MIDLANDS TECHNICAL COLLEGE ACADEMIC CENTER BATHROOM RENOVATIONS AIRPORT CAMPUS

OSE # - H59-N178-CL

ENLARGED TOILET ROOM PLUMBING PLAN, DETAILS, AND SPECIFICATION

P102

1 THIRD FLOOR GROUP TOILET ENLARGED RENOVATION PLAN 1/2" = 1'-0"

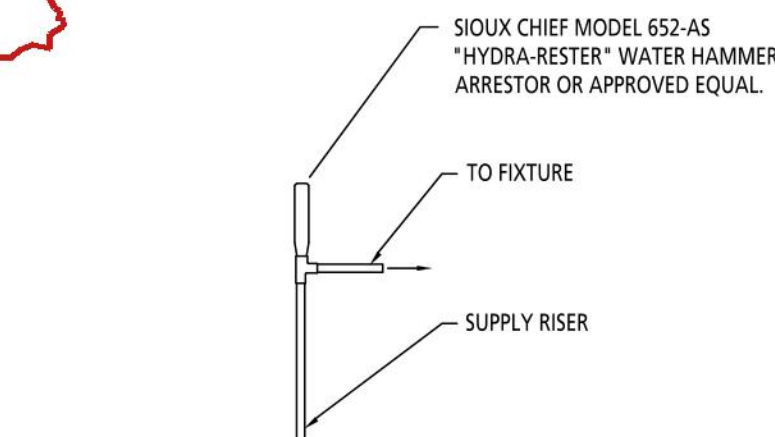
FU COUNT WRONG —
FLUSH VALVE = 6 FU
NOT 4 FU (TANK TYPE)

VENT STACK LOC.
CONFLICTS W/ STRUCT.
COORD. W/ ENGR.

3" SAN UNDERSIZED —
FU COUNT REQ'S 4"
MIN — FIX PIPE SIZE

CLEANOUT MISSING
AT DIRECTION
CHANGE — ADD CO

H/C LABELS SWAPPED
AT LAVATORY —
VERIFY AND CORRECT

verify?

WATER HAMMER ARRESTOR DETAIL

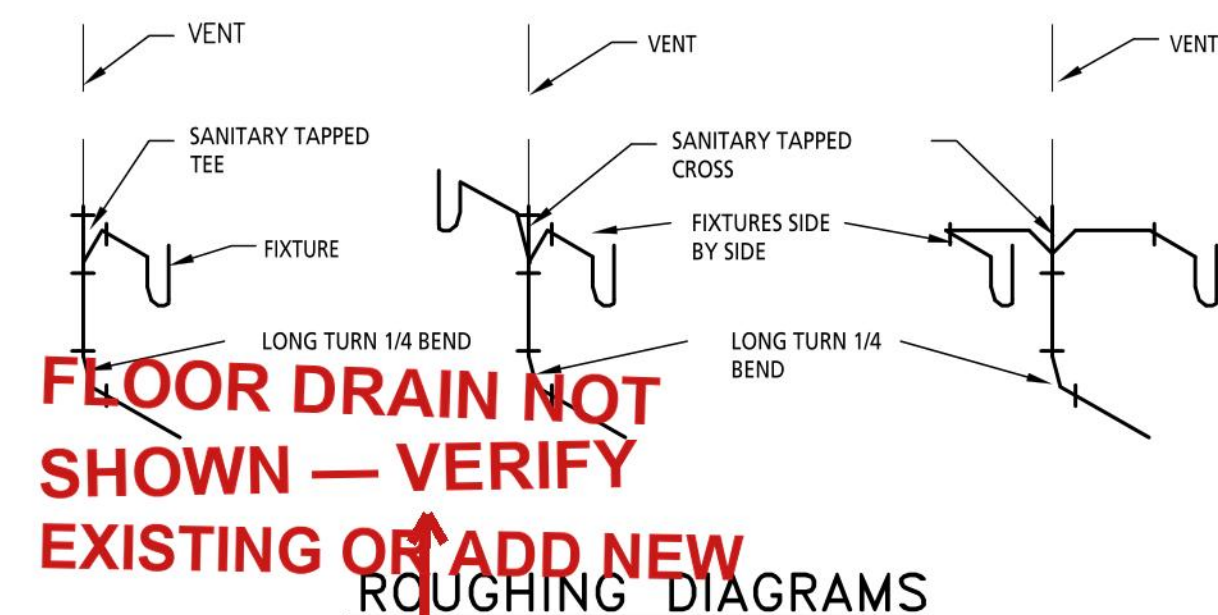
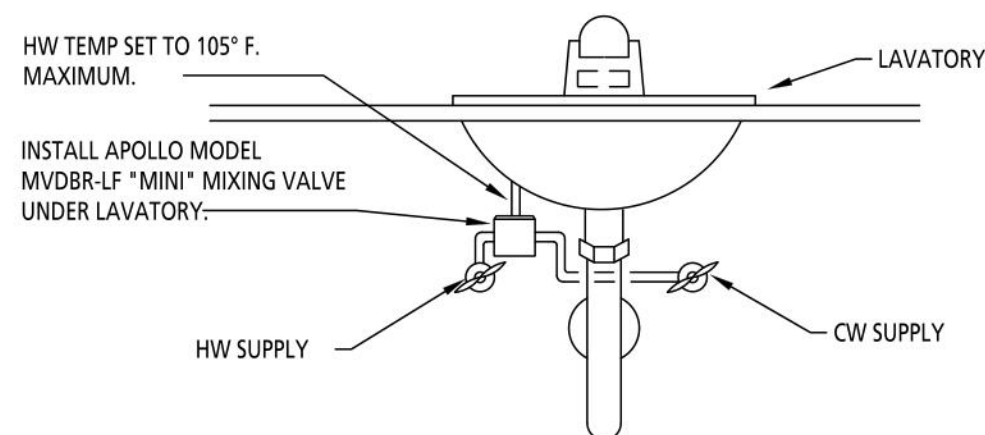
FLOOR DRAIN NOT
SHOWN — VERIFY
EXISTING OR ADD NEW
ROUGHING DIAGRAMS
